1968 Corvette: Service Bulletin: Cracking of the Plenum at the Right Hood Latch Plate

Source: Chevrolet Dealer Service Technical Bulletin

Bulletin No: 68-T-68

Date: Nov. 11, 1968

RIGHT HOOD LATCH REINFORCEMENT PLATE INSTALLATION 1968 CORVETTE

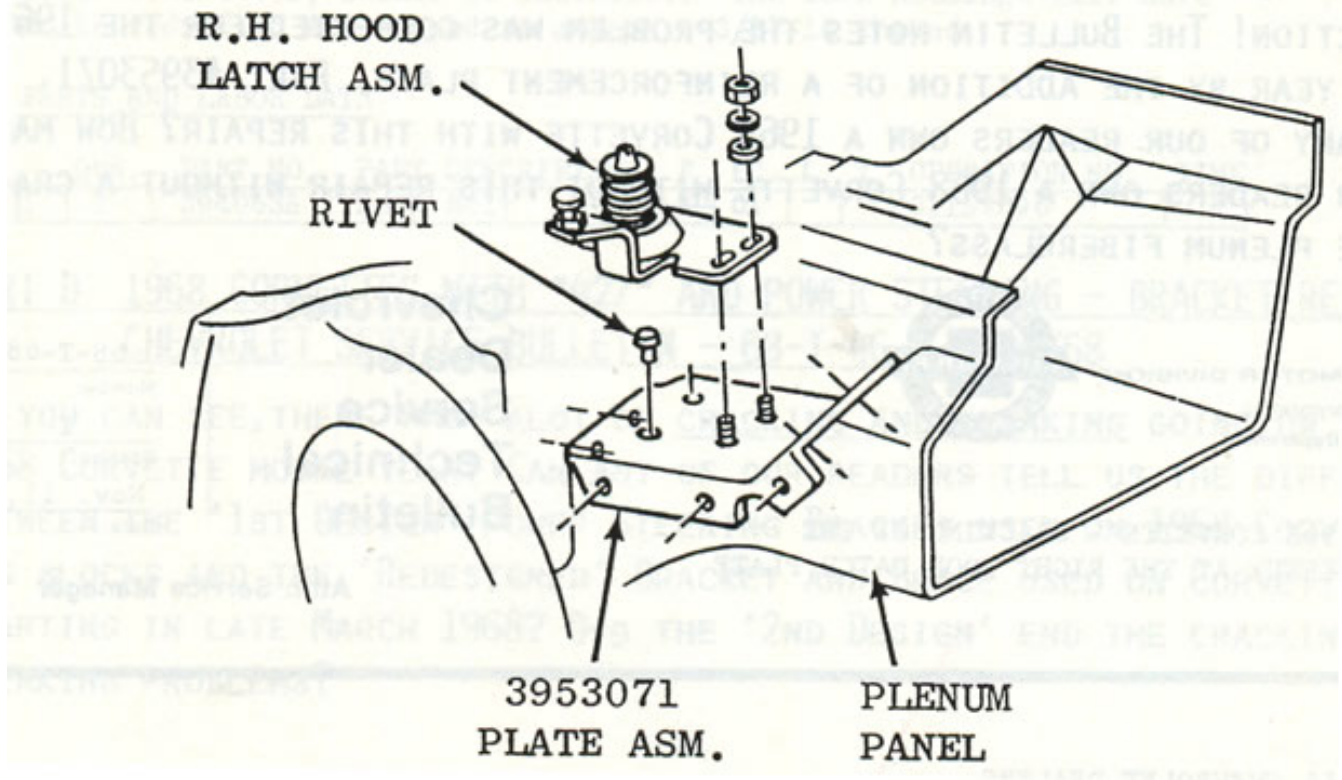
Cracking of the fiber glass plenum in the area of the right hood latch may be experienced on some 1968 Corvettes. This cracking is due to the manufacturing process of the plenum causing a glass rich condition in this area. This condition was corrected at the start of the 1969 production by the addition of a reinforcement plate to the area.

Whenever this cracking condition is encountered in the field, it may be corrected by riveting a reinforcement plate Part No. 3953071 to the outer surface of the plenum as outlined under Service Procedure.

1. Remove right hood latch assembly from the plenum panel and remove cowl vent grille.
2. Drill out two rivets retaining existing stud plate to plenum using a 7/32" dia. drill bit. Remove stud plate through cowl vent opening.
3. Position reinforcement plate on plenum as shown in sketch and drill seven (7) holes 7/32" dia. at hole locations in plate. The two (2) outboard holes are not accessible for drilling.
4. Attach the reinforcement plate to the plenum using 3/16" x 5/8" "Pop" Rivets.
5. Install and adjust right hood latch assembly as outlined in the August 1968 issue of "Chevrolet Service News." Install cowl vent grille.
